**RE: KINROSS Gold Corporation (Echo Bay Mines Ltd.), Lupin Operation
Water License NWB1ULU0008, 2004 Annual Geotechnical Inspection**

2004 GEOTECHNICAL INSPECTION PERIMETER TAILINGS DAMS

LUPIN MINE NUNAVUT

PROJECT NO.: 0256-009-02
DATE: NOVEMBER 8, 2004

PROJECT	ANNUAL INSPECTION OF PERIMETER TAILINGS DAMS				
TITLE	DAM 1A INSPECTION PHOTOS				
PROJECT No.	0256-009-02	DWG. No.	5	REV.	0

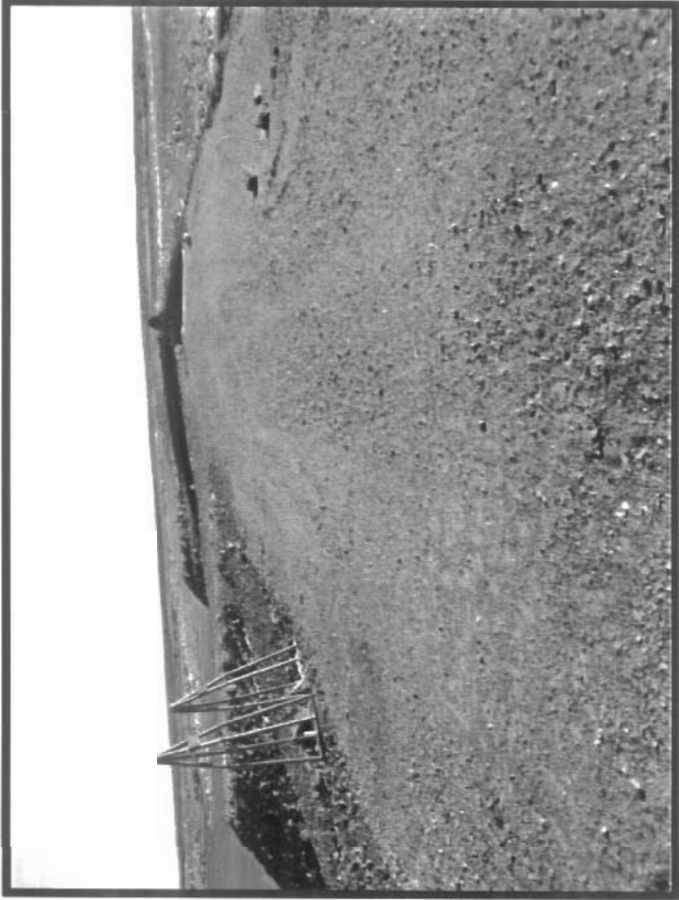
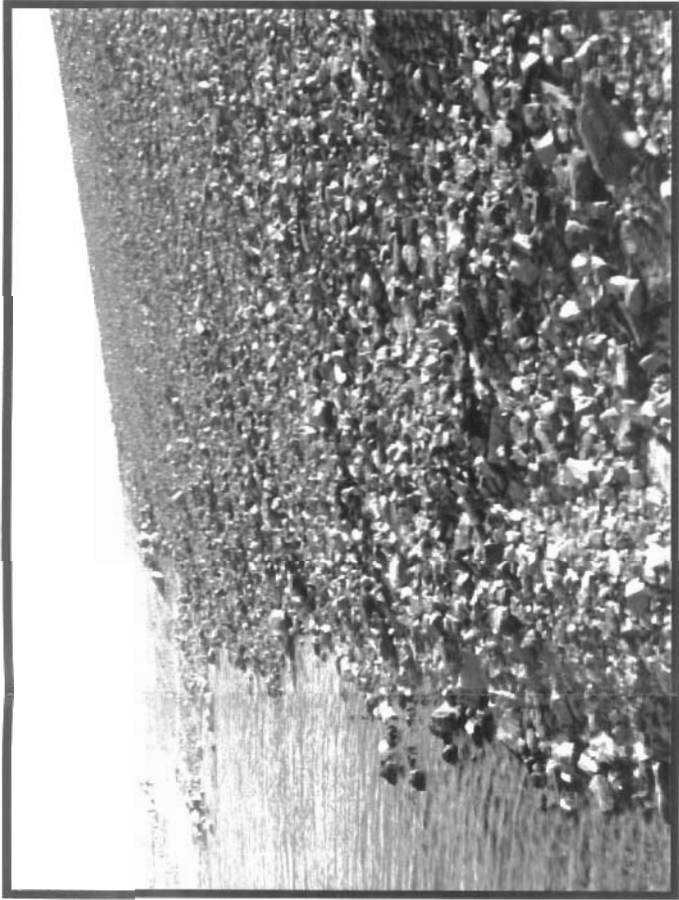
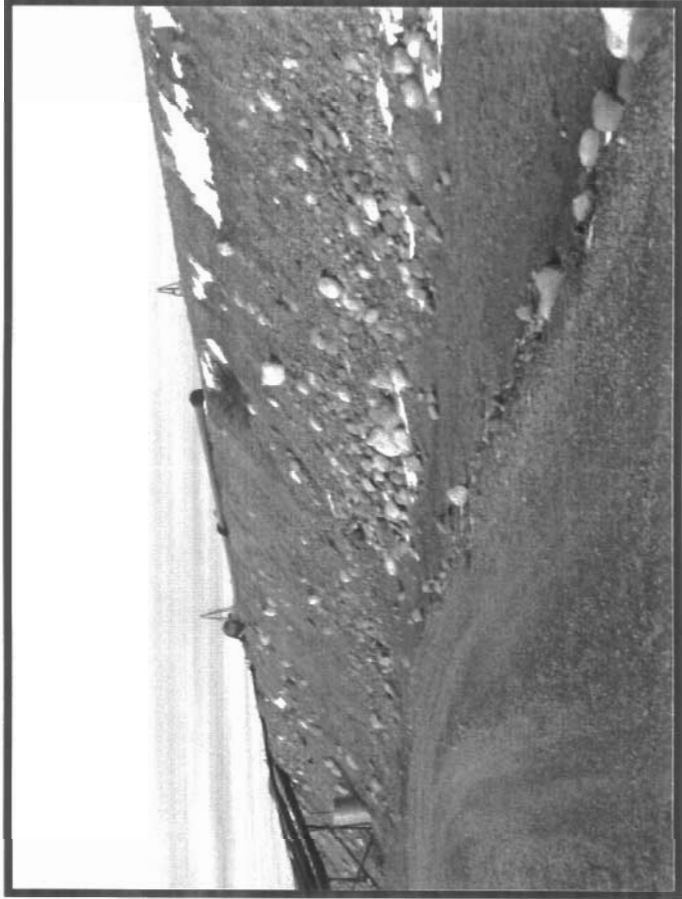
Photo 27 shows some longitudinal cracks formed in the angular rock fill. These cracks were previously noted proximal to the valve locations.

Backfill small sinkhole in the toe berm fill adjacent to the center discharge pipe. Monitor minor cracking at toe of downstream berm and repair as required.

PROJECT	ANNUAL INSPECTION OF PERIMETER TAILINGS DAMS				
TITLE	DAM 4 INSPECTION PHOTOS				
PROJECT No.	0256-009-02	DWG No.	10	REV.	0

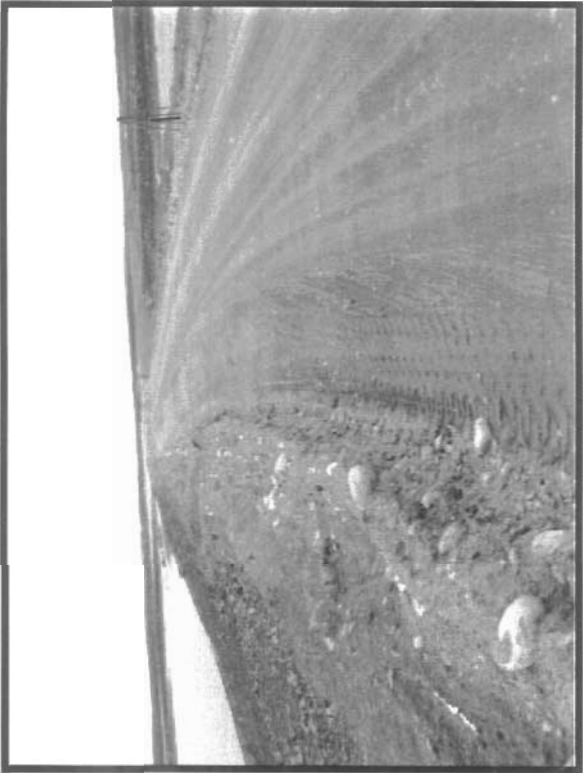
Photo 60 shows a significant windrow which has been formed on the crest of Dam 4 at its west abutment. This crest will have to be regraded to a proper grade to prevent future erosion.

Grade windrows on the crest to allow for proper crest drainage. Backfill new erosional gullies at the west and east ends of the dam backslope.

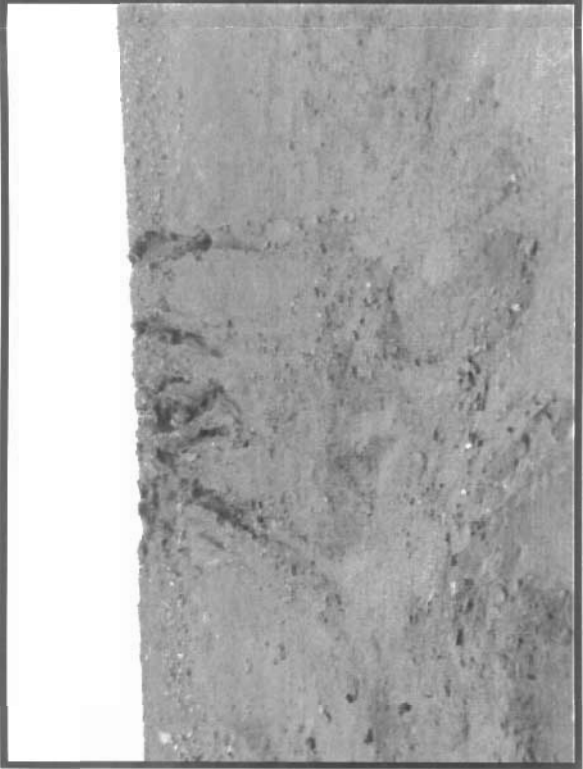
Photo 68 shows four erosional gullies which should be backfilled.

Photo 67 shows a narrow erosional gully which should be backfilled.

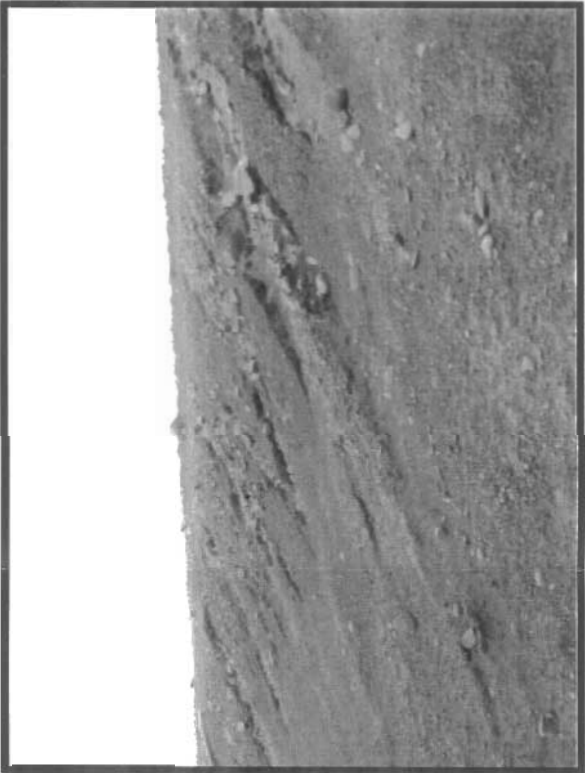
Photo 71 shows a number of erosional gullies right at the west abutment on the downstream side. These should be backfilled to prevent any additional erosion.

PROJECT	ANNUAL INSPECTION OF PERIMETER TAILINGS DAMS				
TITLE	DAM 6 INSPECTION PHOTOS				
PROJECT No.	0256-009-02	DWG No.	12	REV.	0

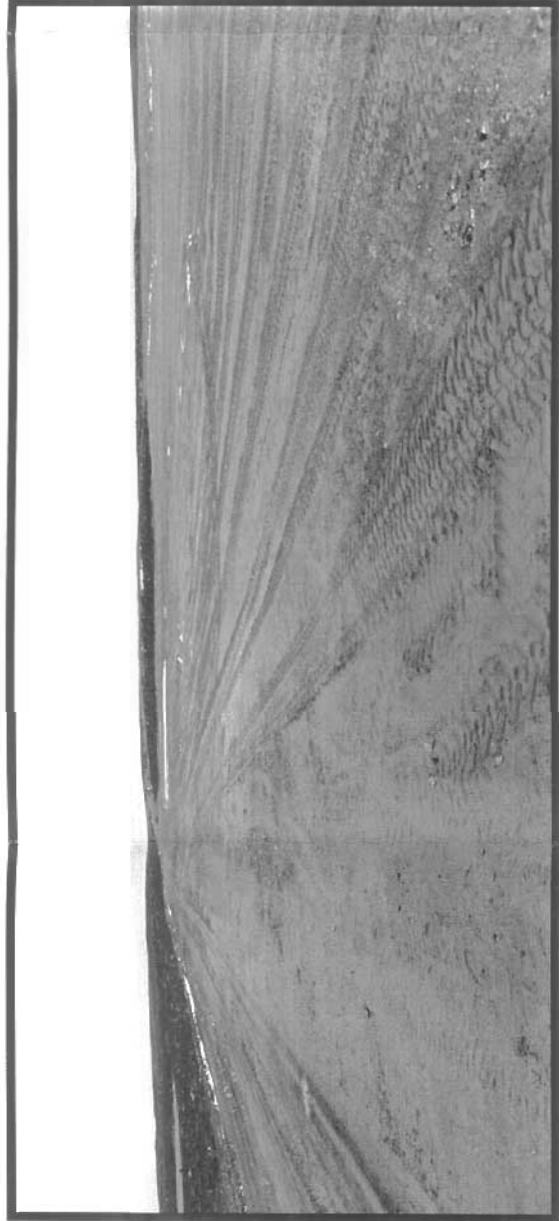
Photo 45 & 46 are a two shot panoramic showing the upstream side and the crest of Dam 6. A local high point exists some 100 metres to the east of this dam. As a result, localized drainage reports to the remnant pond.

Photo 47 shows a view of the downstream toe looking towards the north. Construction traffic has caused a number of ruts and pushed up some windrows on the toe crest.

MAINTENANCE RECOMMENDATIONS:	Cover placement on the upstream side has reduced the freeboard amount on the reclaimed dam. Important to ensure that surface runoff in the spring does not overtop the dam and lead to erosion of the dam.
CONCLUSIONS:	The dam is in good condition but its performance should be monitored during spring freshet and significant rainfall events.

Long Term Plot for TD4-3
(Crest of Dam 4, West End, Just East of TD4-4)

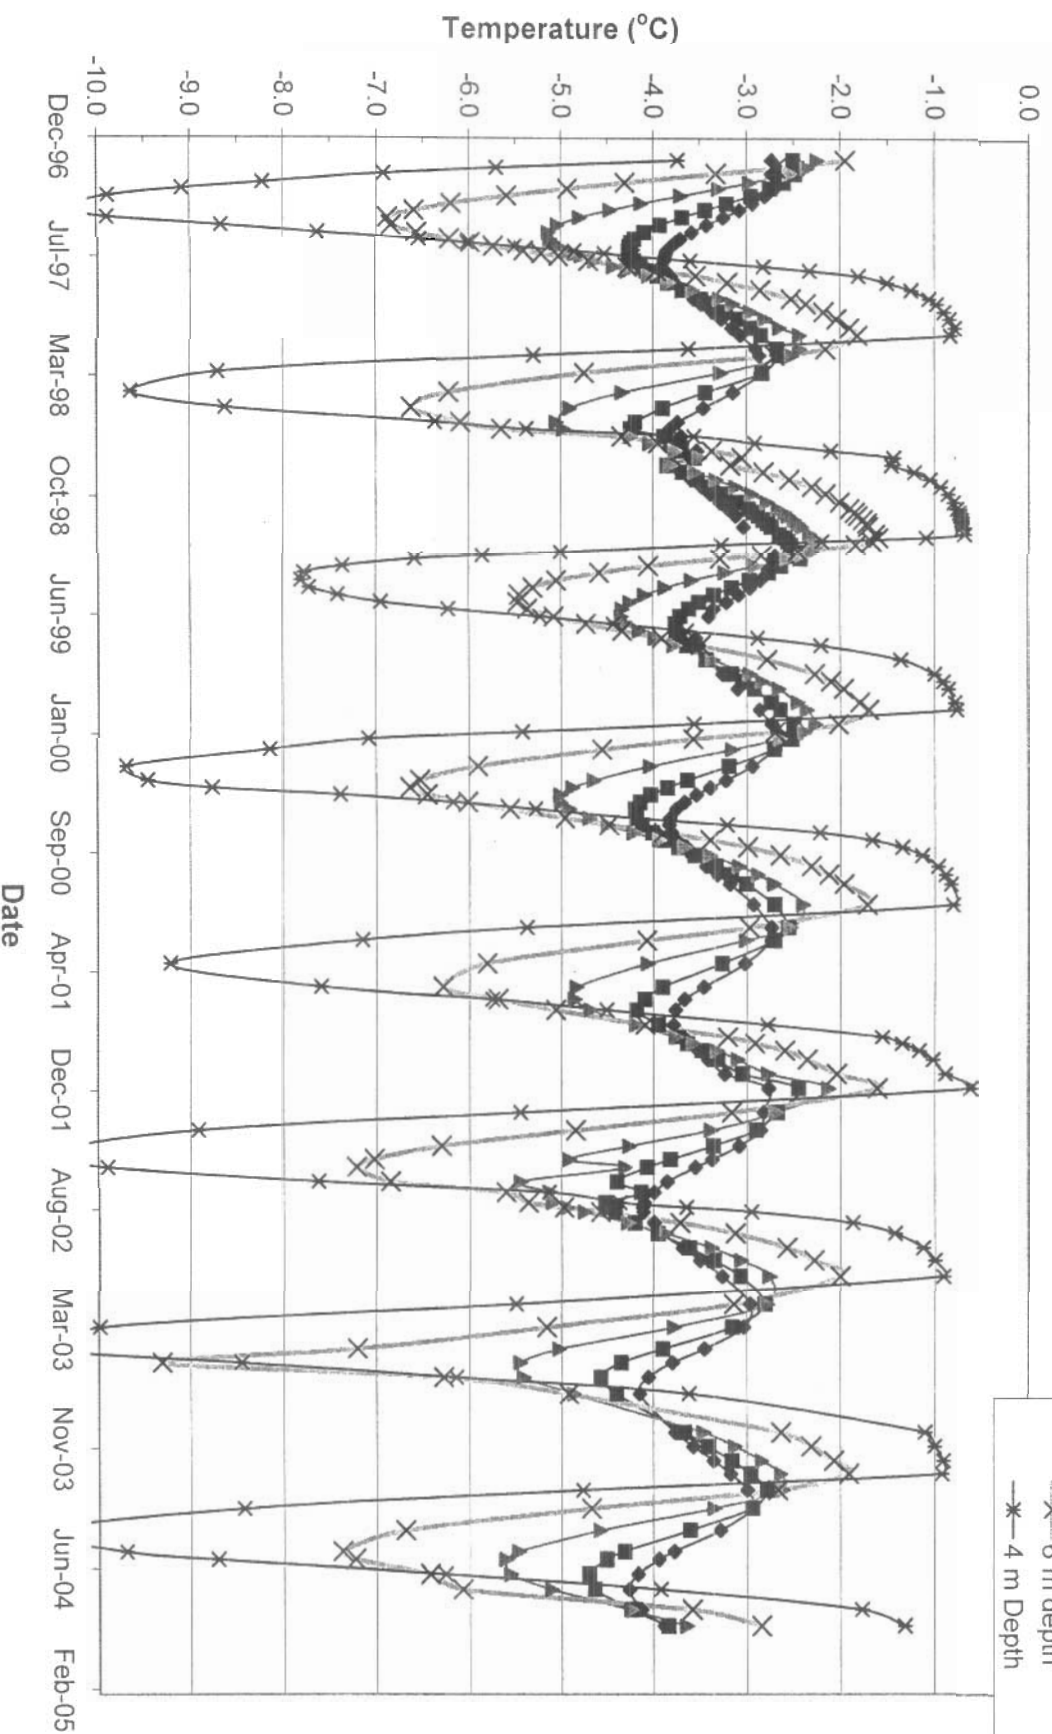
Thermistor TD4-3 displayed only subzero temperatures below 4 m depth. Below a depth of 6 m (approximately embankment fill thickness), the temperatures have all been colder than -2.0°C with no signs of significant warming.

Long Term Plot for TD4-4
(Crest of Dam 4, Far West End)

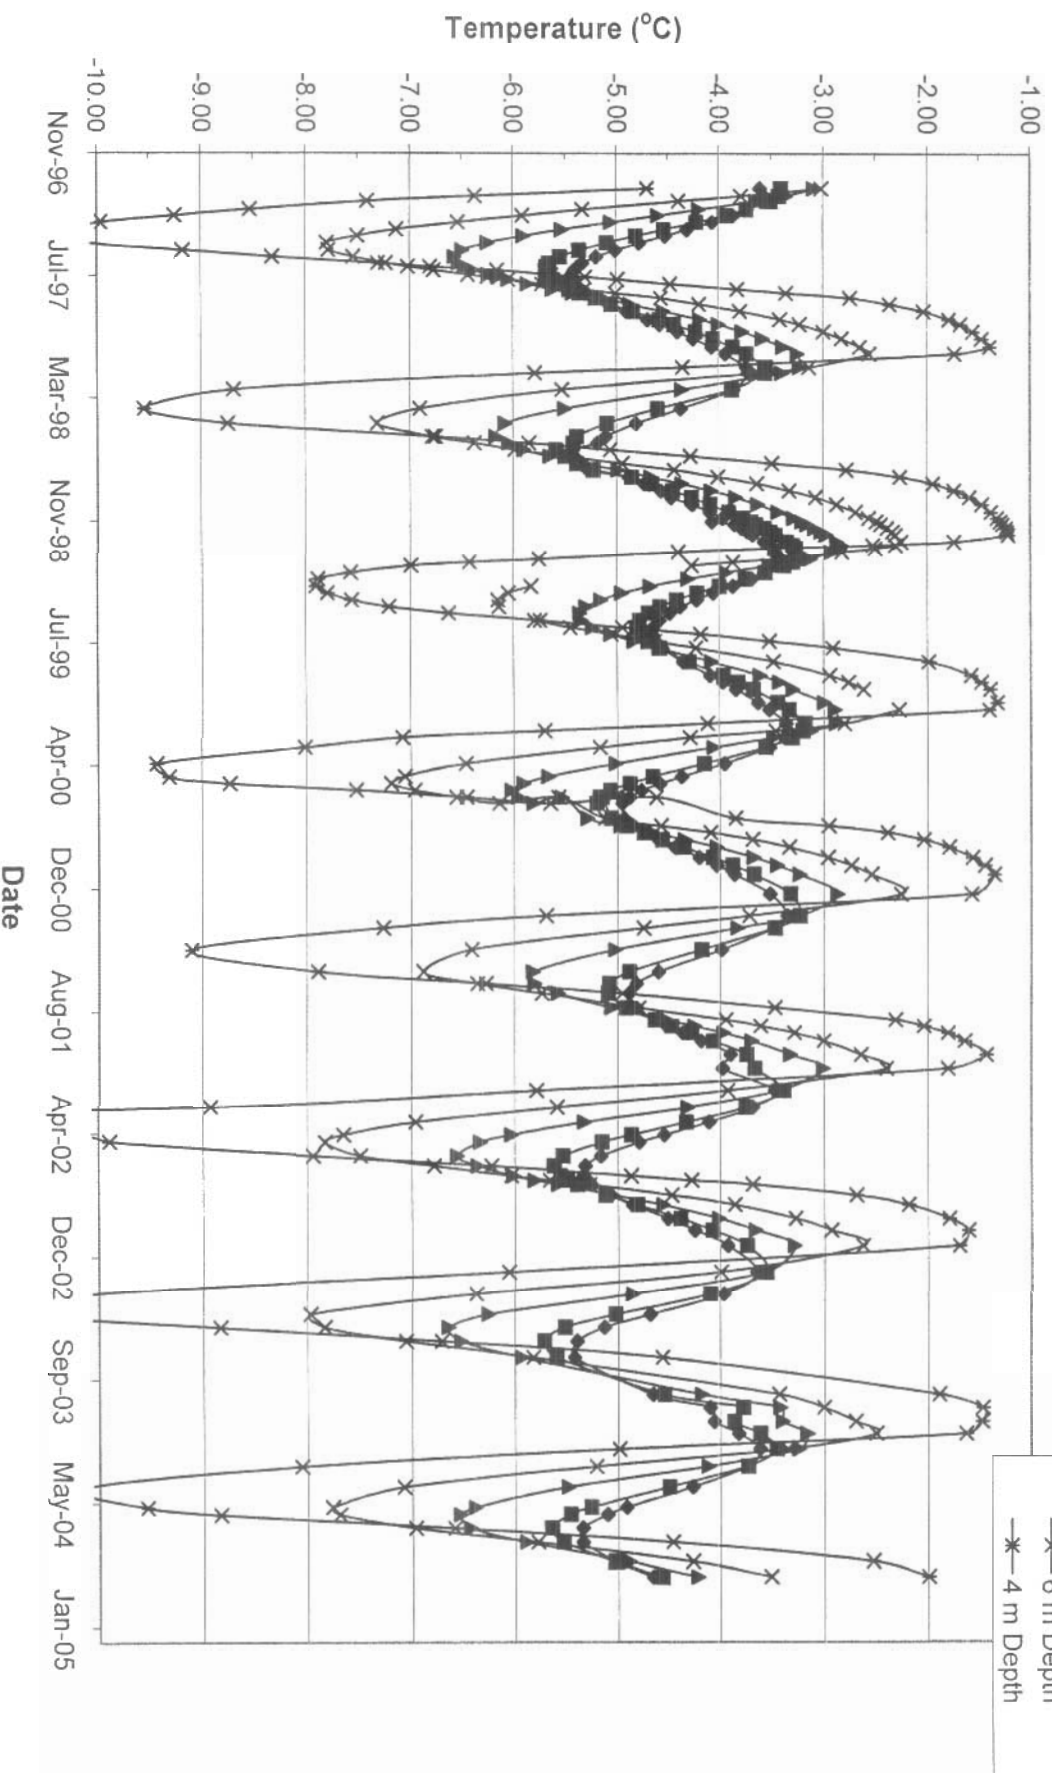
Thermistor TD4-4 displayed only subzero temperatures below 4 m depth. Below a depth of 6 m (approximately embankment fill thickness), the subsurface temperatures have all been colder than -2.7°C with no signs of significant warming.
